ORDINANCE 506

**AN ORDINANCE OF THE CITY COUNCIL OF THE CITY OF SAN RAMON
AMENDING THE CITY ZONING MAP TO EXPAND THE CROW CANYON
SPECIFIC PLAN BOUNDARY AREA AND ADOPTING DEVELOPMENT
STANDARDS AND ZONING REGULATIONS (SPA 20-800-001 & IS 20-250-001)**

**Exhibit 2 - Errata Summary Table of Refinements and Clarifications to the Crow Canyon Specific Plan Update
November 2, 2020**

Exhibit 1: Rezone Map

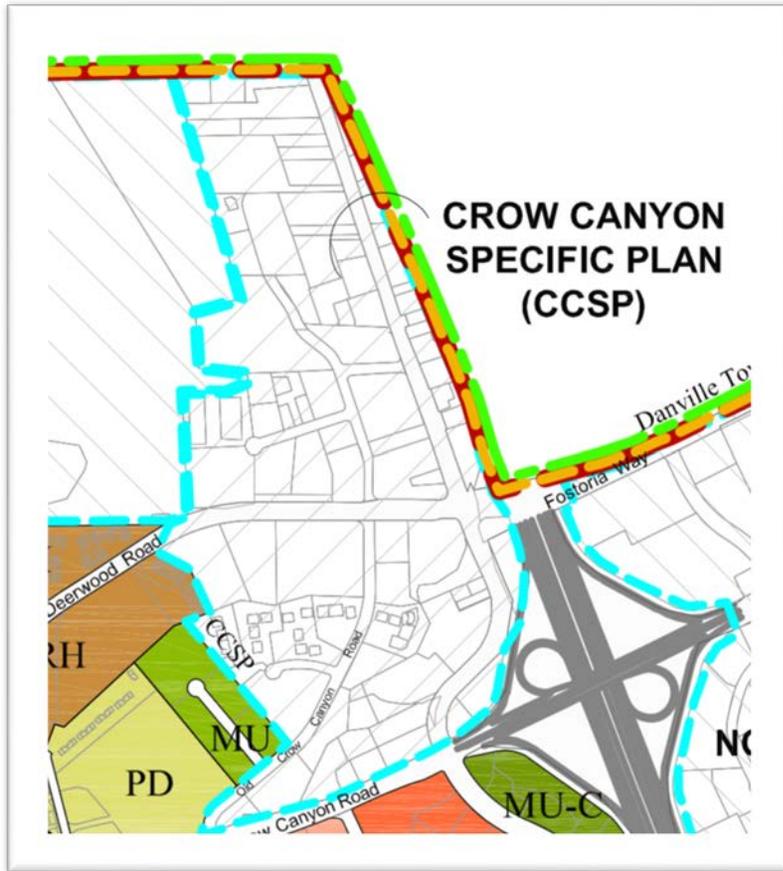
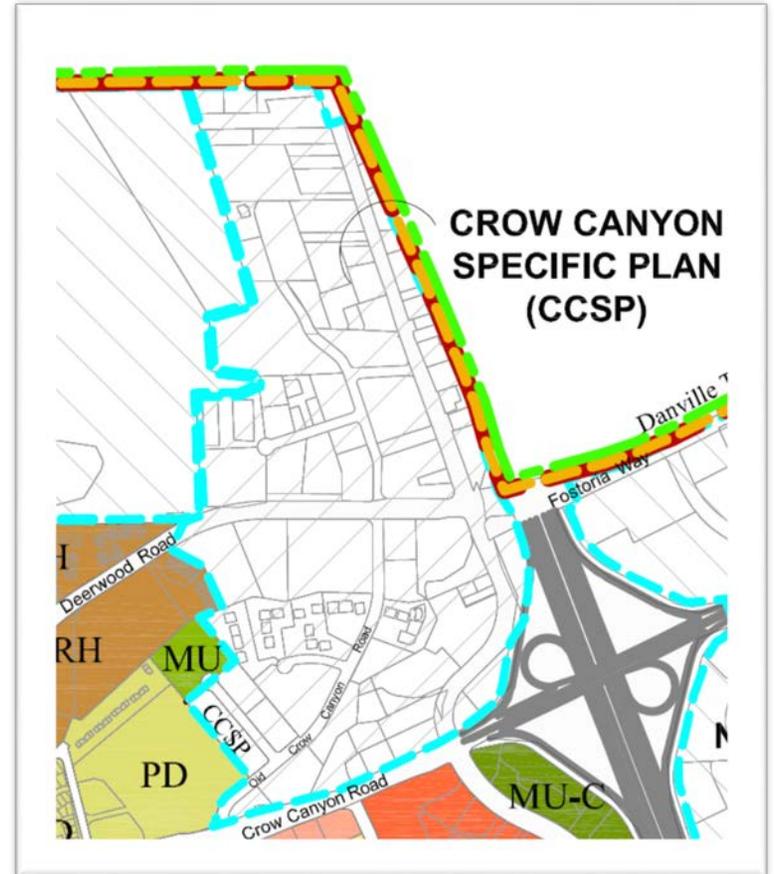
Section 1. The Zoning Map (Appendix A to the Zoning Ordinance) shall be amended to designate the real property located within the Crow Canyon Specific Plan to those designations as indicated on the attached Exhibit 1.
